CITY OF ALBUQUERQUE

RE: Freezer Expansion Phase 4
EL Encanto INC. (Bueno Foods)
2001 4th St. SW
Revised Grading & Drainage Plan
Engineer's Stamp Date: 06/30/21
Hydrology File: L14D001A

SHEET NAME **GRADING AND** DRAINAGE PLAN

REVISION SHEET C-004

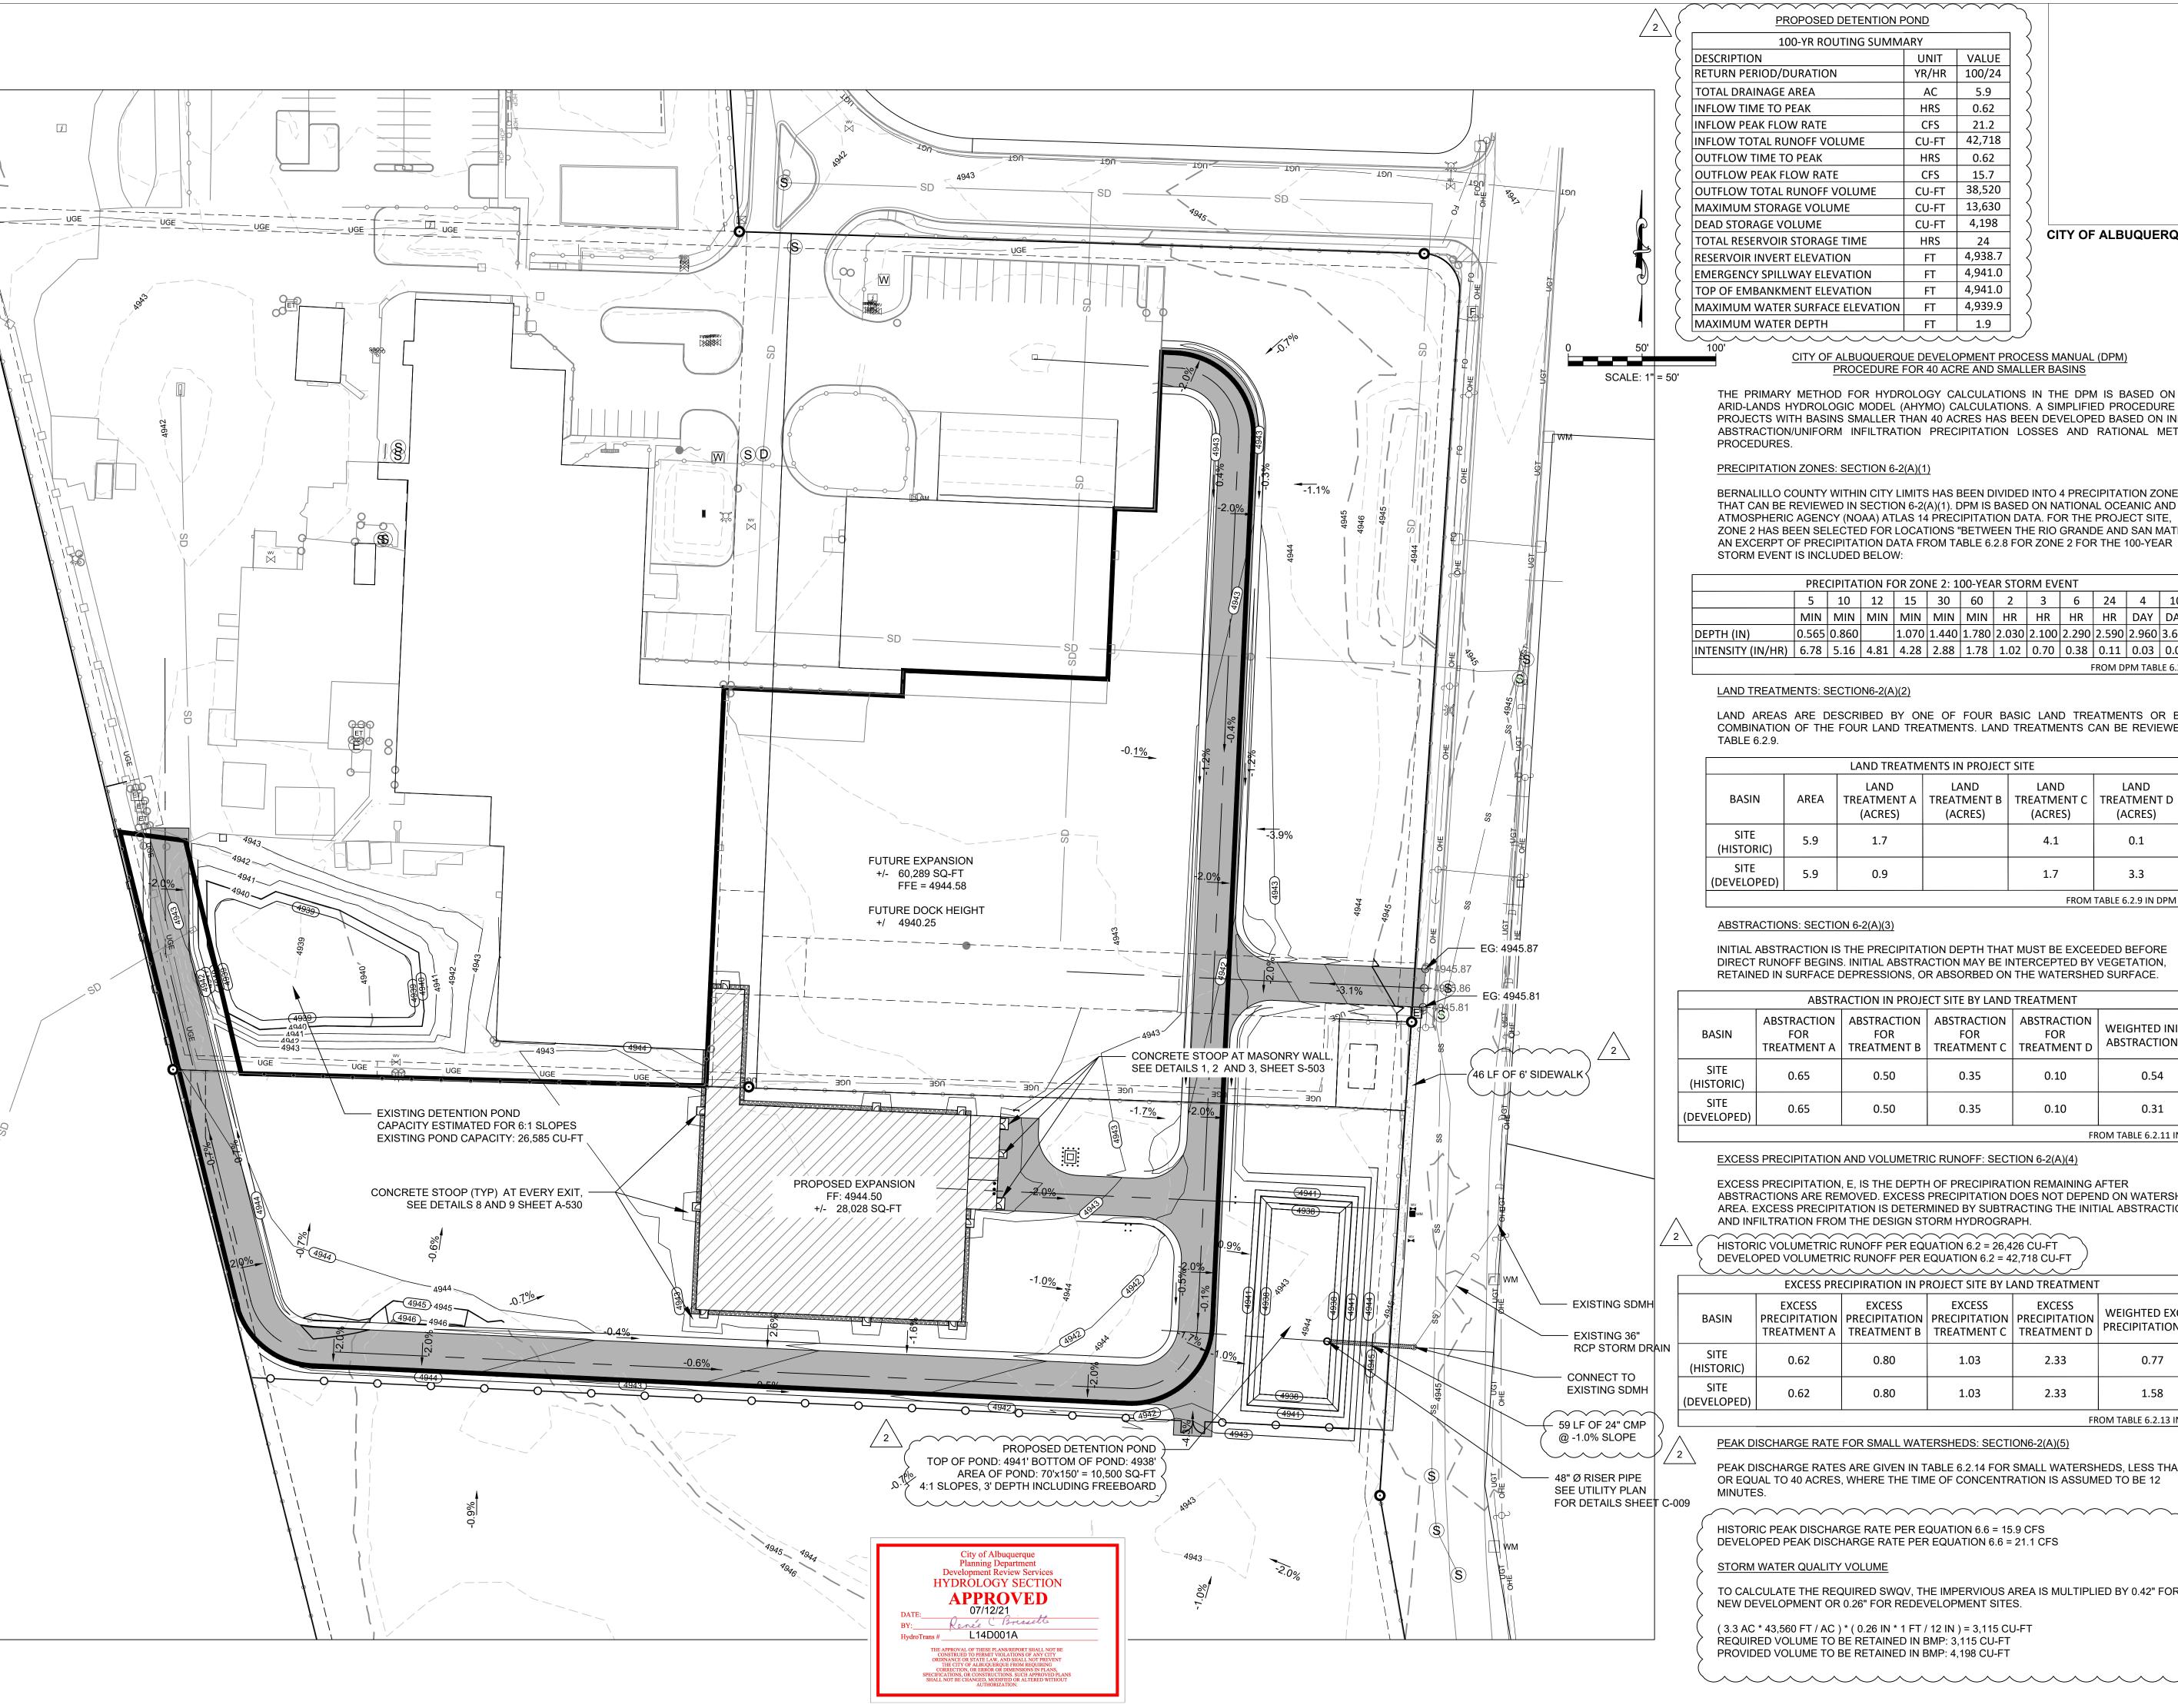
Based upon the information provided in your submittal received 07/01/2021, the Revised Grading and Drainage Plan is approved for Building Permit.

Please provide Drainage Covenant for the stormwater quality ponds per Article 6-15(C) of the DPM prior to Permanent Release of Occupancy. Please submit an electronic file of the Covenant and Exhibit for completeness to Marion G. Velasquez at mgvelasquez@cabq.gov. Once the electronic file is approved for completeness, please submit the original copies along with the \$ 25.00 recording fee check made payable to Bernalillo County to Marion on the 4th floor of Plaza de Sol. Please note that Hydrology will need a pdf copy of the recorded Drainage Covenant prior to Hydrology's approval of Permanent Release of Occupancy.
